Addendum 03

PROJECT: Cedar Cliff Schools Connector Addition and Renovation
194 Walnut St
Cedarville, Ohio 45314

PROJECT #: 25056.00

This addendum form is a part of the Contract Documents and modifies the Construction Documents dated June 24, 2026, with amendments and additions noted below.

E1.2

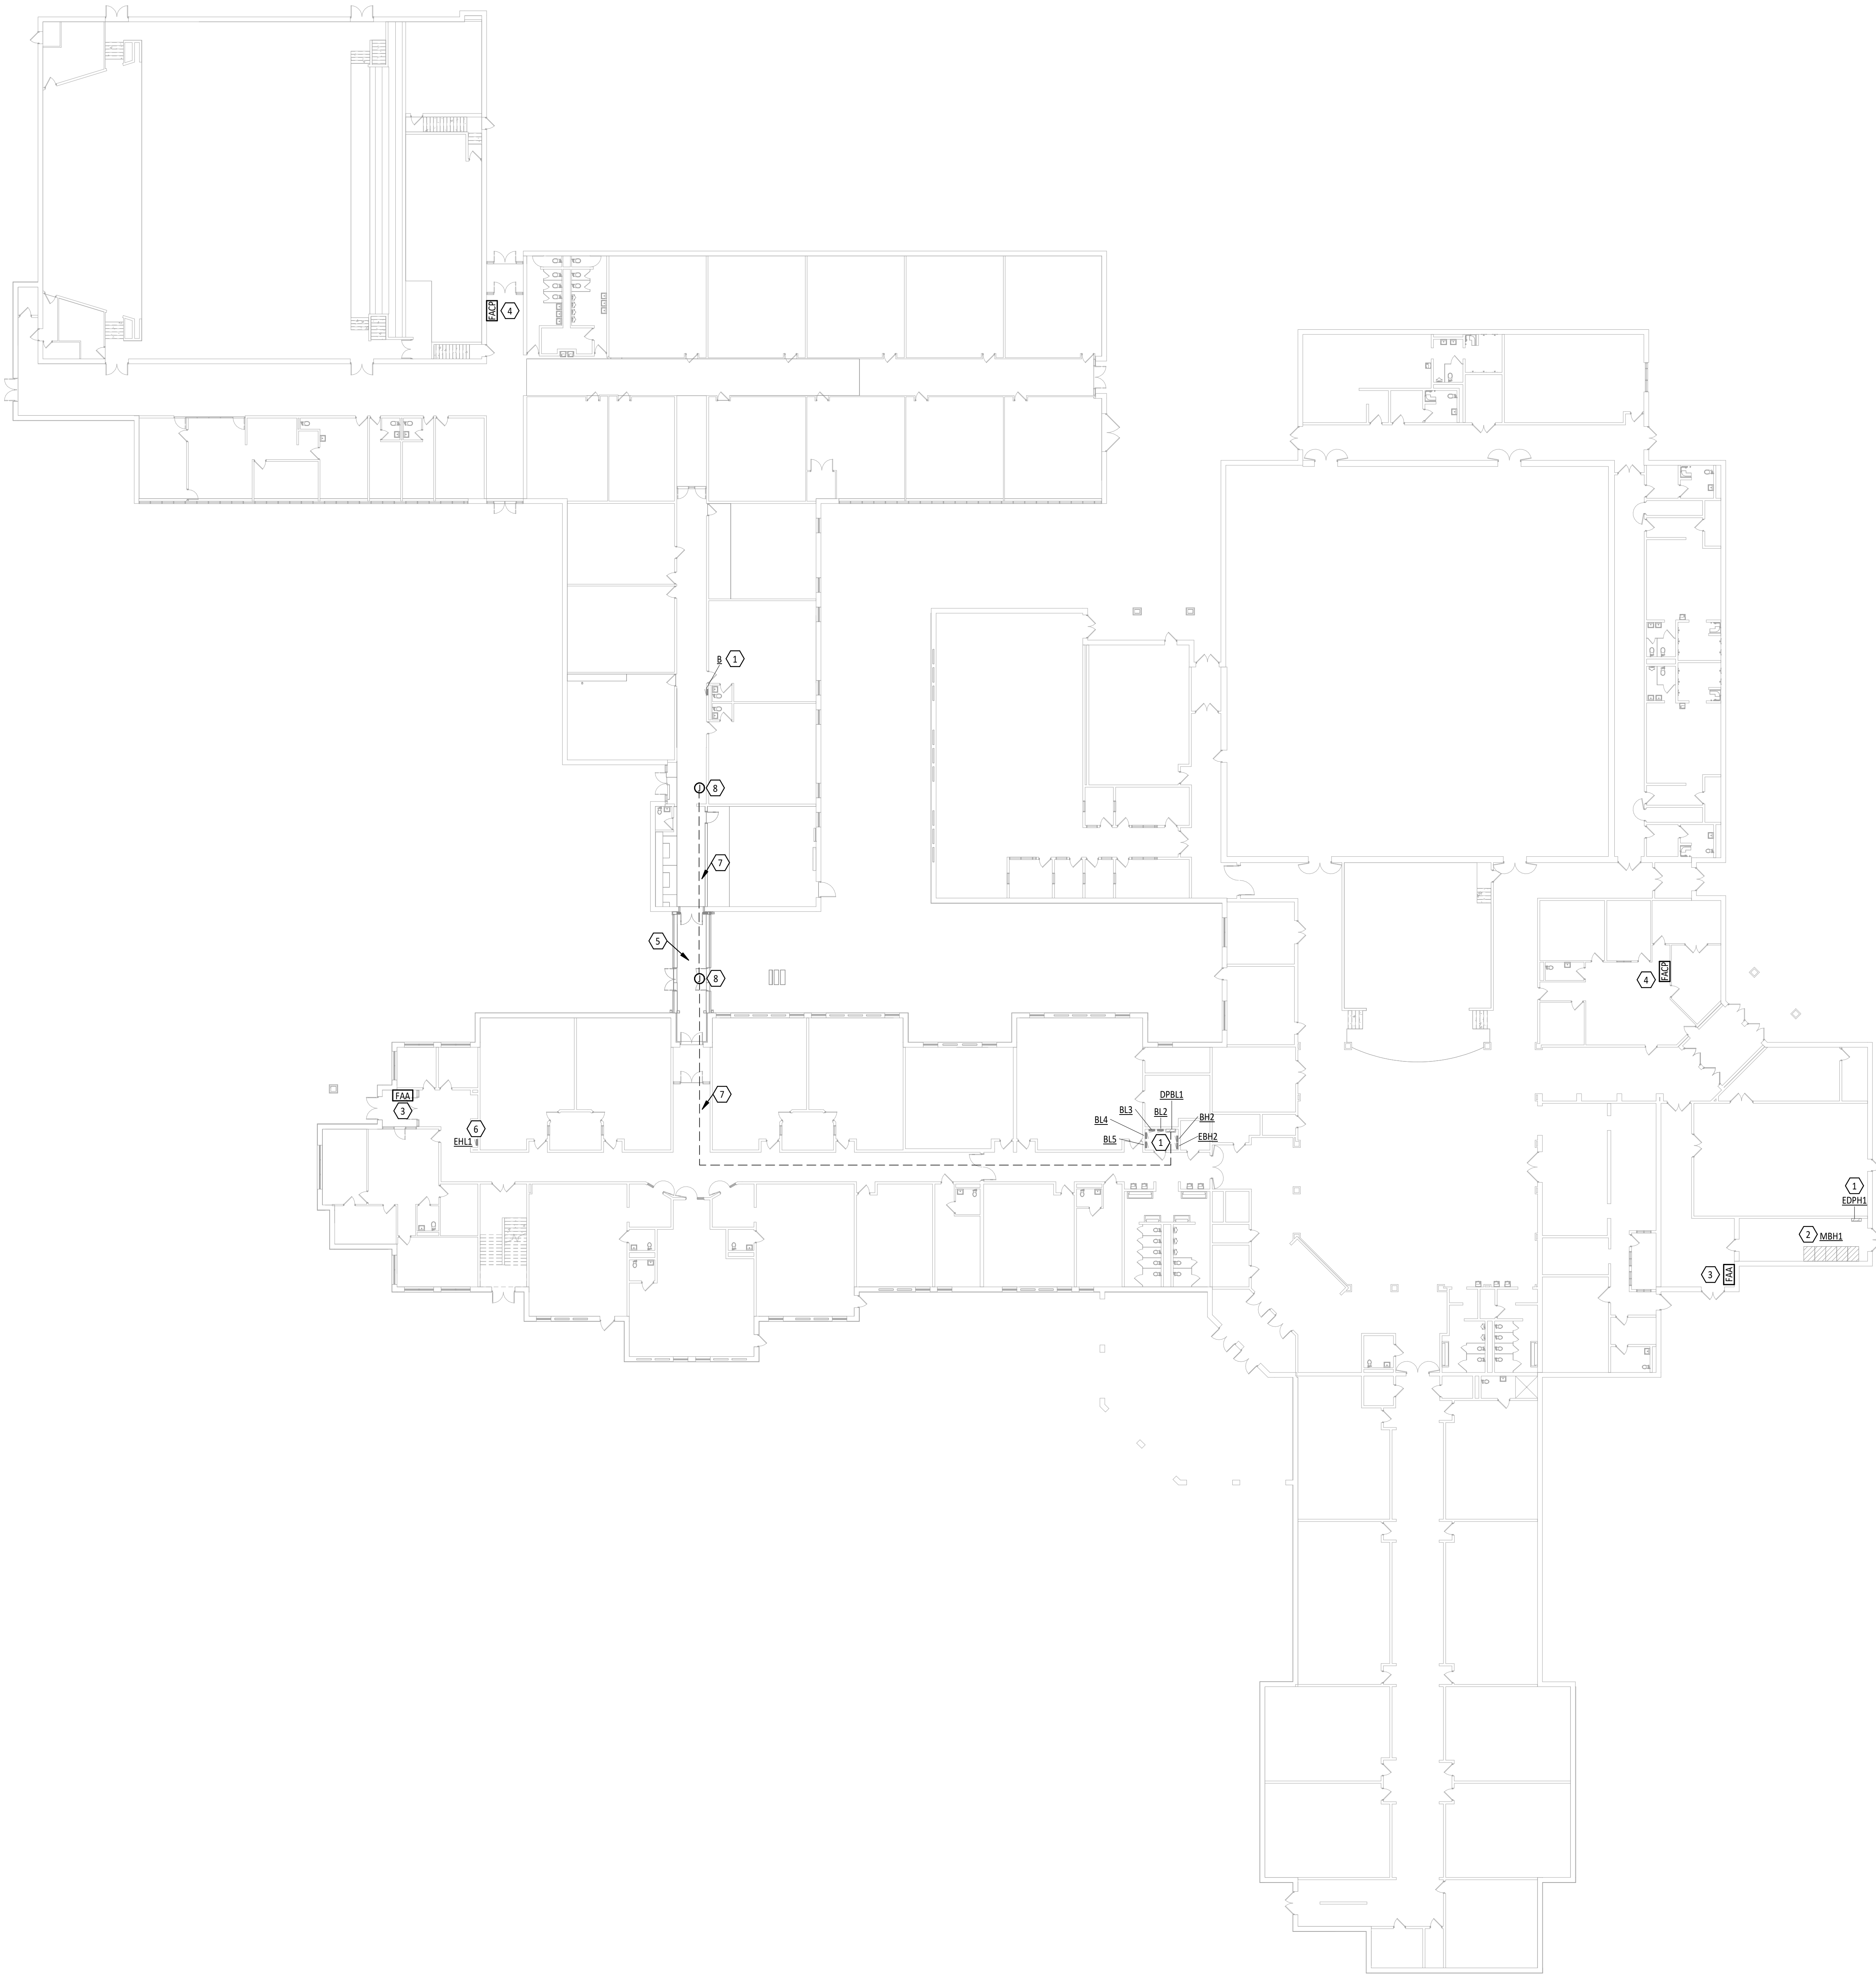
1. Drawing Sheet E1.2 Detail 1 First Floor Systems Plan – Unit A
 - a. New fire alarm devices shall be tied to their respective existing building fire alarm systems.

3 EXISTING ELEMENTARY SCHOOL FIRE ALARM RISER DIAGRAM
E1.3 NTS

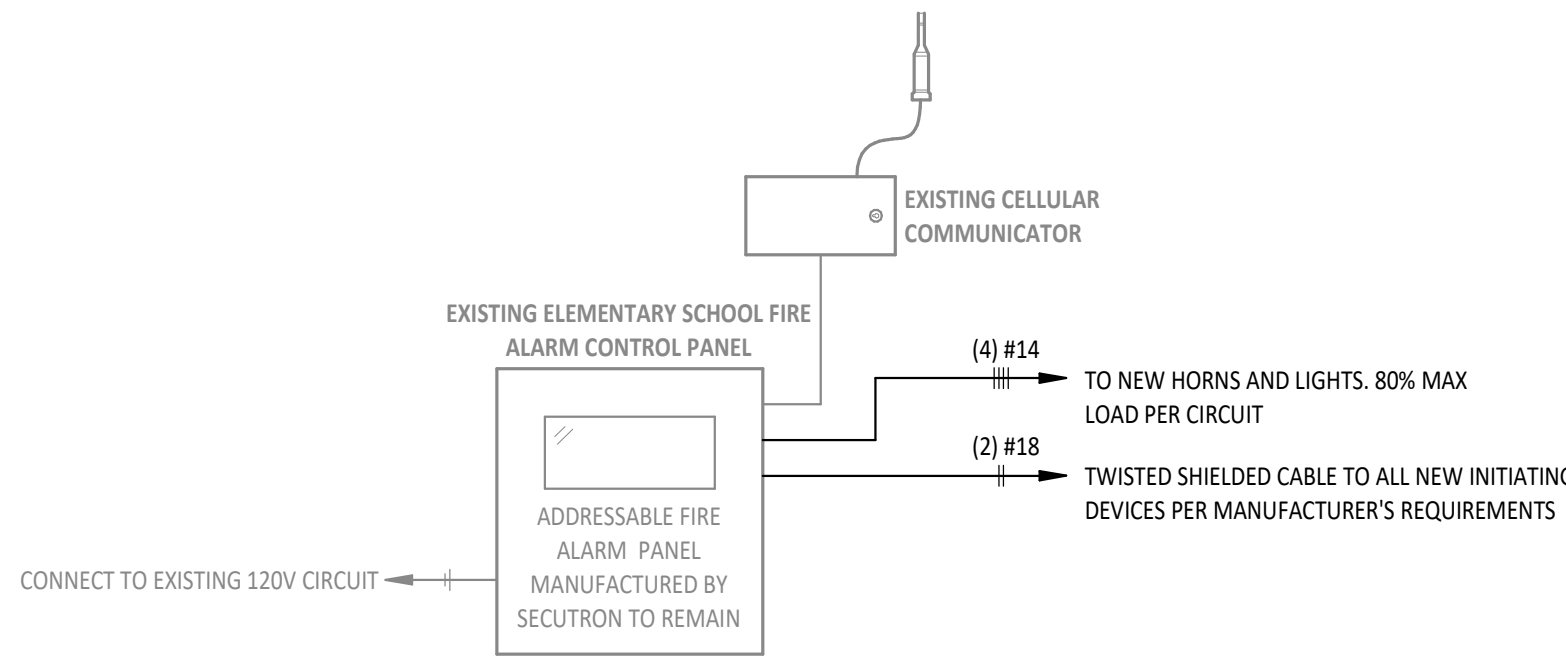
4. Drawing Sheet E1.3 Detail 3 Existing Elementary School Fire Alarm Riser Diagram
 - a. Added detail to show existing elementary school fire alarm control panel is existing to remain.

2 EXISTING HIGH SCHOOL FIRE ALARM RISER DIAGRAM
E1.3 NTS

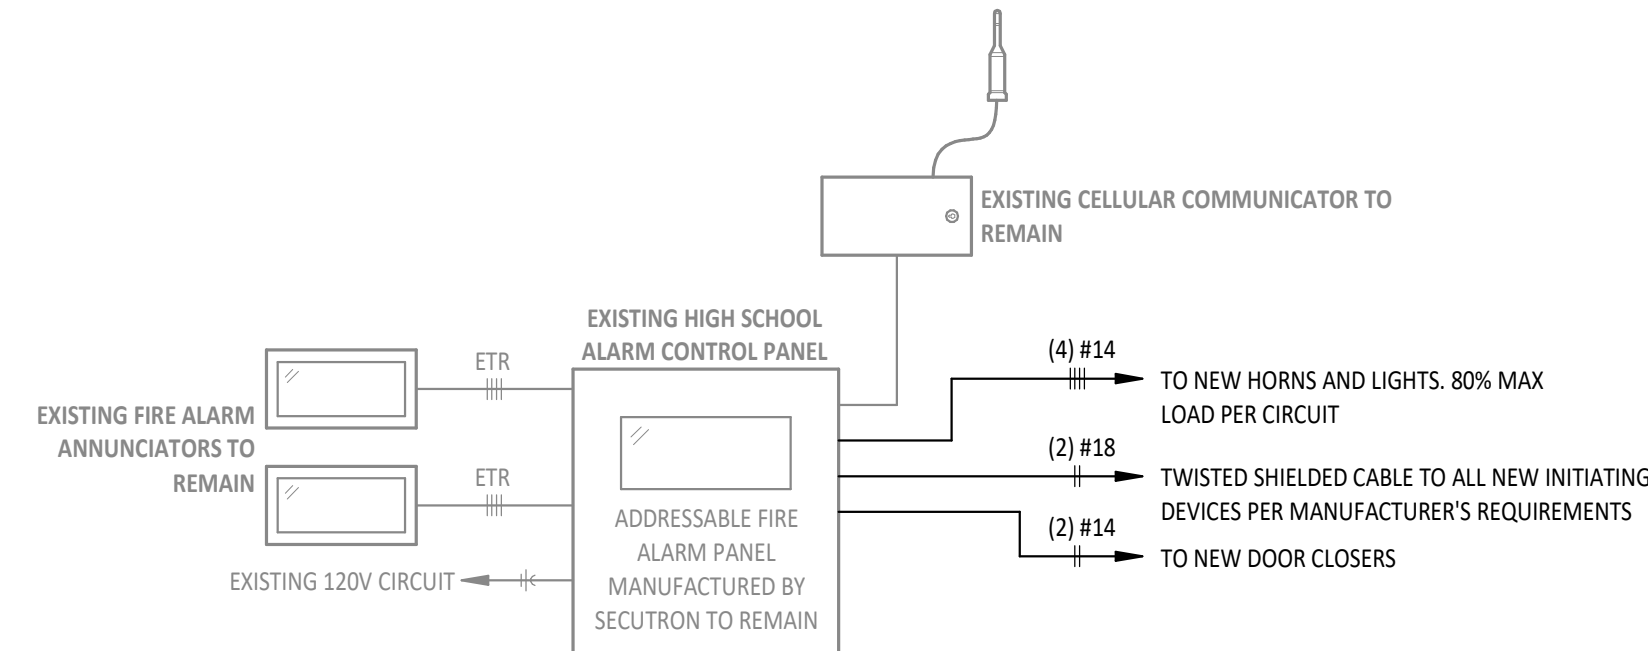
- a. Remove network connection to elementary school fire alarm control panel.
 - b. Remove scope for replacing fire alarm control panel and annunciator panels.

1 OVERALL FIRST FLOOR POWER & SYSTEMS PLAN
E1.3 1" = 20'-0"

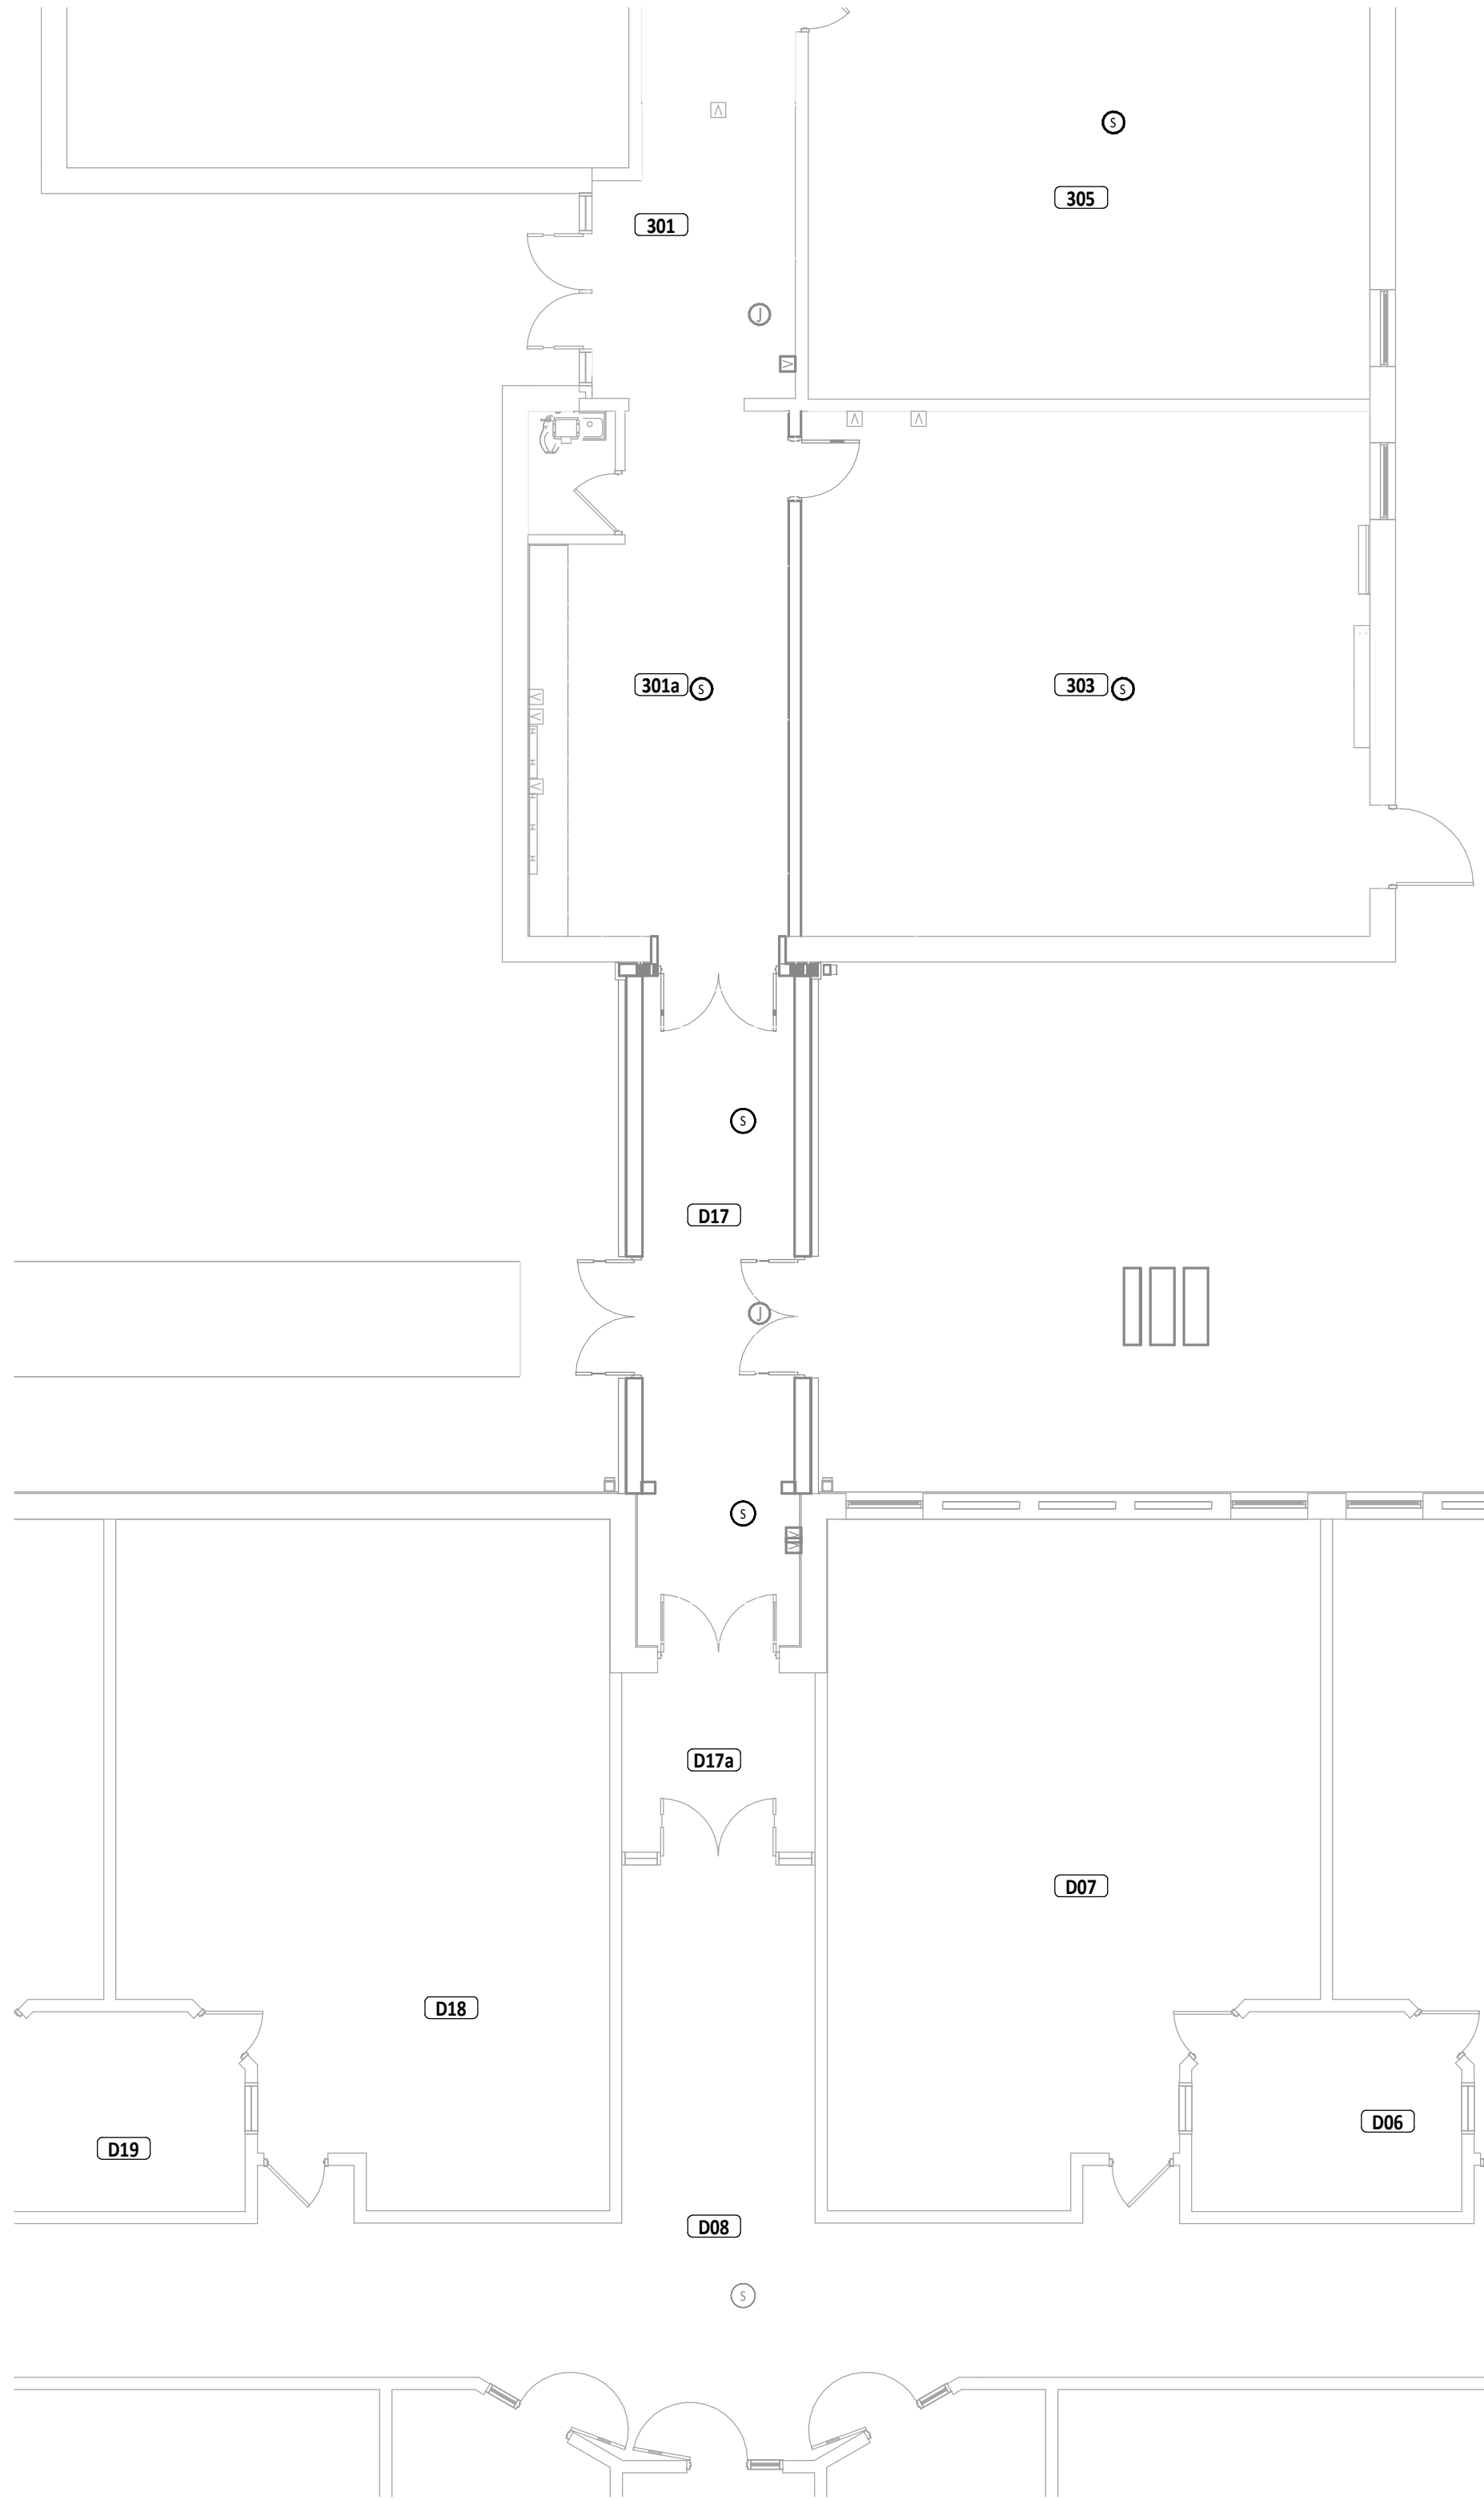
2. Drawing Sheet E1.3 Detail 1 Overall First Floor Power & Systems Plan
 - a. Existing fire alarm control panels and annunciator panels in both buildings are now existing to remain and shall not be replaced with new.

- b. Remove fiber cabling between fire alarm panels. Panels shall not be networked together.
3. Drawing Sheet E1.3 Detail 2 Existing High School Fire Alarm Riser Diagram
